NHTSA #: 11V-250 TC #: 2011-167

ACTION REQUIRED:

Remove and replace stabilizer jack bolts

Stabilizer Jack applications

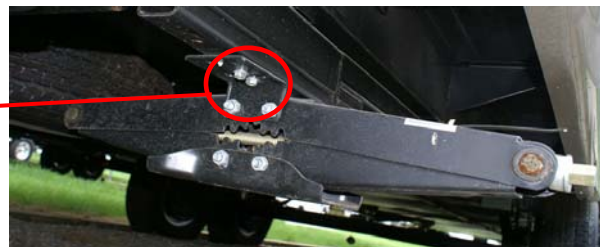
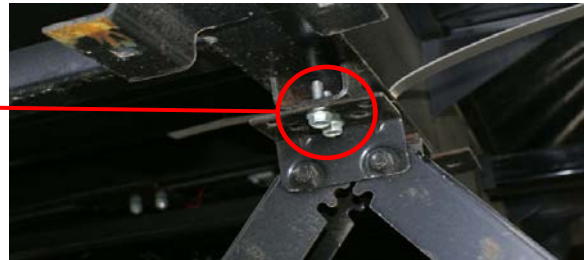
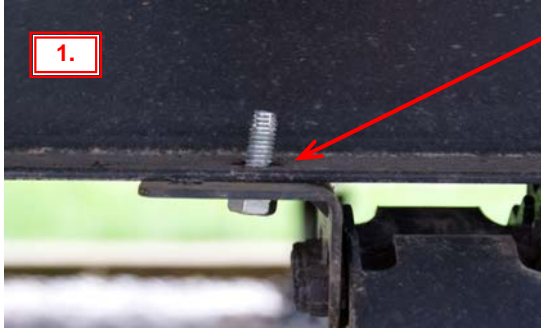
1. Remove (all) existing stabilizer jack bolts and replace with the bolts and washers (where applicable per pictures) supplied in the kit.

Electric Stabilizer Jack application

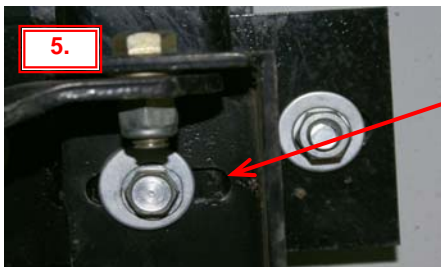
1. On the electric jack application, (2) additional bolts will need to be added. Drill (2) 9/32" holes in the frame rail bracket slot.

NOTE: Before drilling you will need to determine the best location for the holes. You will need to avoid any existing slots in the frame rail. Examine the frame rail to locate the slots and drill the hole so it will miss them. You will need a sharp drill bit to drill through the frame.

Install (2) bolts and washers in the newly drilled holes. Replace the existing bolts with those supplied in the kit. Re-use the original washers. (See Fig. 5)

Drill a hole and install additional (2) bolts and washers. Replace existing bolts (reuse the original washers)
